STAFF REPORT - SUMMATION

Center Point Subdivision Preliminary Plat Process

CASE NUMBER(s): UDC-19-00391

PROJECT: Center Point Subdivision, 2nd Filing

**PRELIMINARY PLAT
FOR
CENTER POINT
SUBDIVISION, 2nd FILING**

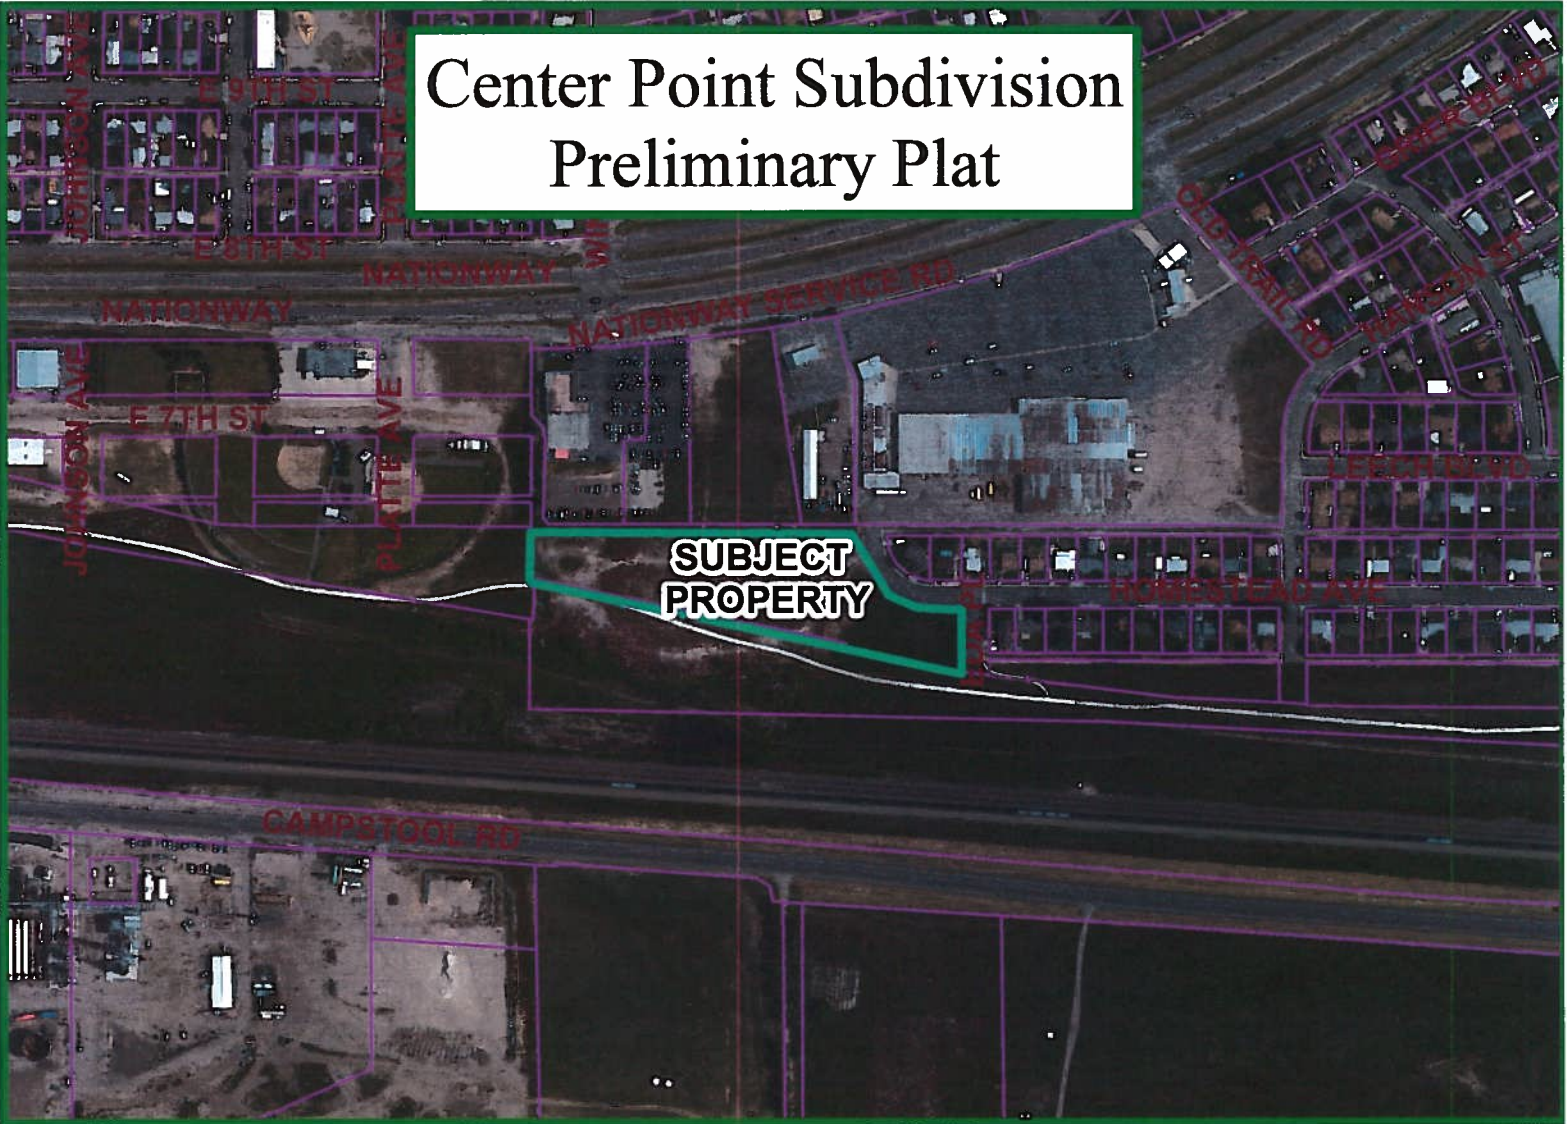
c. Per Section 4.3.4 of the UDC, all right-of-way width shall be a minimum 56-feet. Revise right-of-way width between Lot 10, Block 1 and Lot 8, Block 3.

- d. Revise right-of-way at northwest corner of Lot 10, Block 1 so that it extends due west without a variation.***
- e. Revise right-of-way at northeast corner of Lot 12, Block 3 so that it extends due south to allow for possible t-intersection configuration.***
- f. Clearly show and call-out all BOPU Easements.***
- g. The vacation of the alley requires a separate vacation ordinance as the alley was originally platted as part of the Homestead Addition, First Filing Replat.***

- Board of Public Utilities (Linda Gunter)
 - o **(Condition 1(f))** Clearly show and call-out the BOPU's Easement.
- Development (Tawn Hillenbrand)
 - o **(FYI)** Proposed lots qualify as SD2 (UDC 5.1.5.b). SD2 lots are allowed in the MR zone district. MR zone must meet the design standards of Section 6.6.3.
 - o **(Condition 1(a))** Open space and drainage lot dedication, ownership, and maintenance is not clear, per notes 5 and 6 on the Preliminary Plat Map. Clarification of ownership and maintenance of open space is required per Section 4.4.6 of the UDC.

- **(Condition 1(g))** The vacation of the alley may require a separate vacation ordinance as the alley was originally platted as part of the Homestead Addition, First Filing Replat.

- Engineering Department – Drainage (Mike Vinson)
 - **(Condition 1(b))** A Drainage Impact Study will be required demonstrating City criteria will be met.

- **(FYI)** Lots 4-7, Block 1 driveway/access configuration will not be approved if the current non-conventional intersection shown is proposed.
 - **(Condition 1(c))** The Right of way shown by Lot 10, Block 1 and Lot 8, Block 3 is only 55' and should be 56' minimum per UDC.

- **(FYI)** The centerline of the street should be the middle of the right of way.
 - **(Condition 1(d))** The right of way shown at NW corner of Lot 10, Block 1 should extend due west (no variation).

- **(Condition 1(e))** At the NE corner of Lot 12, Block 3 the Right of way line should extend due south to allow for possible t-intersection configurations.

- Forestry (Mark Ellison)
 - **(FYI)** The proposed Plat does not show detached sidewalks. The UDC, chapter 4.3 requires a detached sidewalk with a 7 ft. tree lawn between the sidewalk and the curb for residential streets. Detached sidewalks with street trees improve quality of life for residents, increases property values and reduces maintenance for sidewalks and streets.

- o **(FYI)** It appears the intersection of the existing Homestead Avenue with the proposed Homestead Court could be problematic for pedestrians and vehicle interaction, as well as, resident driveways. This is due to skew of the intersections. Therefore, could the intersection be aligned to accommodate a more perpendicular intersection of the two streets using a curve?

- Urban Planning (Richard Zita)
 - o **(FYI)** Intersection at Homestead needs to be closer to ninety degrees to provide safety access and egress. Verify with traffic and civil engineering.

- o **(FYI)** Access/egress to lots 4,5 and 6 are too close to the intersection. Verify with traffic and engineering.
 - o **(FYI)** Would prefer to see tree lawn dedicated throughout to insure a more consistent and effective street tree planting.
